ADDENDUM NUMBER 2

MARCUS CENTER FOR THE
PERFORMING ARTS
PHASE IV HVAC RENOVATIONS
Site #270, Bldg. #50
929 North Water Street
Milwaukee, WI 53202

Project Number: O038-13450

Date of Addendum: February 19, 2013

PARTIAL MECHANICAL FLOOR PLAN- ROOM 701

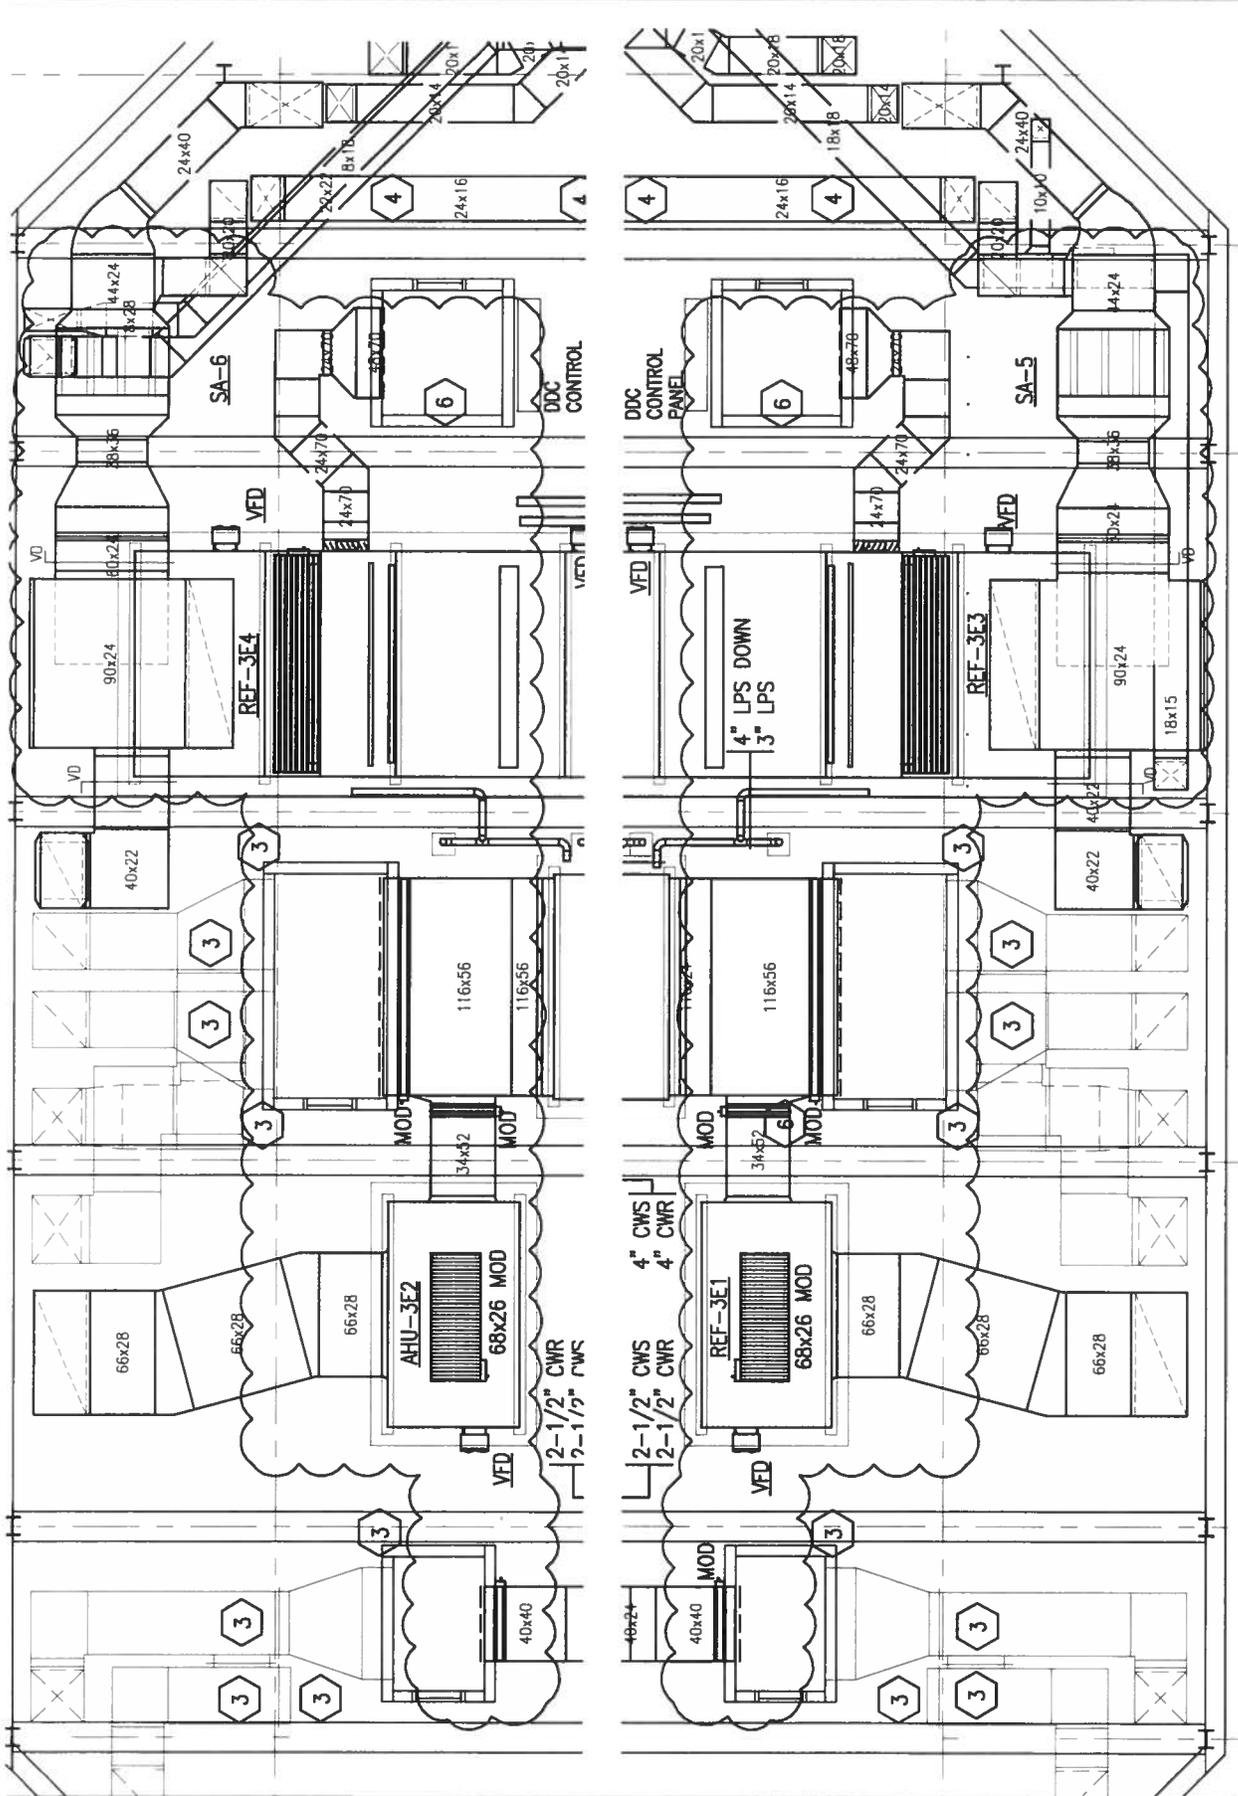
2. **ADD** New Work Sheet Notes No. 6. Repair, patch, seal and paint obsolete outside air intake opening to match existing.”
3. **ADD** Partial Mechanical Floor Plan Room 701 Addendum Drawing ADM-1 attached to and issued as part of this Addendum 2.

APPENDUM DRAWING REVISES ORIGINAL DRAWING 2/M100 OF THE 2-04-2013 CONTRACT DOCUMENT
